Application to modify a development consent

MOD 7

Permission to Lodge: Section 75W Modification (No.7) of DA-453-12-2002-i – Container Terminal Upgrade – 7-15 Penrhyn Road, Port Botany

**RE: Patrick Stevedores Operations No.2 – Proposed Modification to Existing
Container Terminal, Botany Bay Local Government Area
(DA-453-12-2002-I MOD 7)**

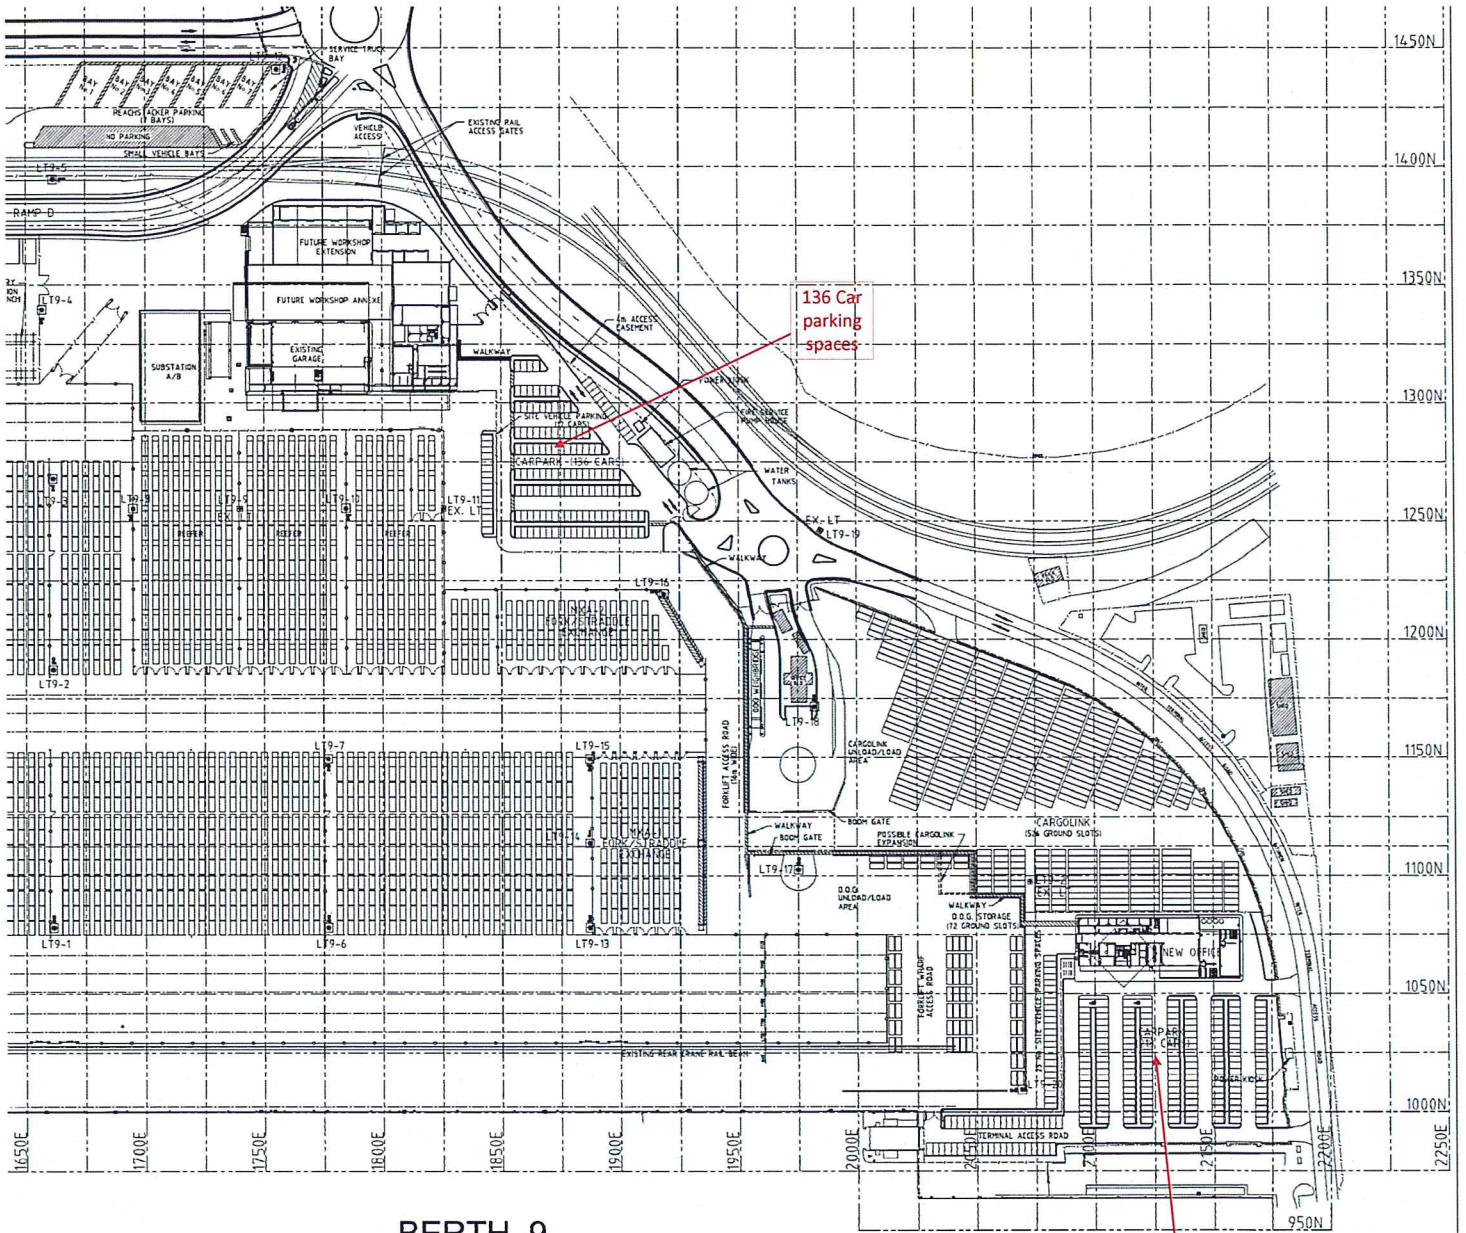
Thanks for the information. We still have a number of queries in relation to carparking. Can you please provide a response to the following:

- confirm that staff will reduce from 511 to 271 not 241 as stated on page 21 of the traffic report; - The exact numbers are currently in negotiation with the Unions and FWA and have a slight fluctuation. The 271 is correct although the number may change slightly (+/- 10%) based on the outcome of discussions.

- The number of car parking spaces presented in the modification document contained an error. The actual number of car parking spaces required:
 - Administration and Operations Car park - **220**
 - Maintenance Car Park - **136**
 - Total - **356** (not 465)
- All contractor temporary car parking facilities during construction works will be within the site compounds handed over to the contractors. These site compounds are described in figure 2-5 of the Environmental Assessment. No roadside parking will be allowed.
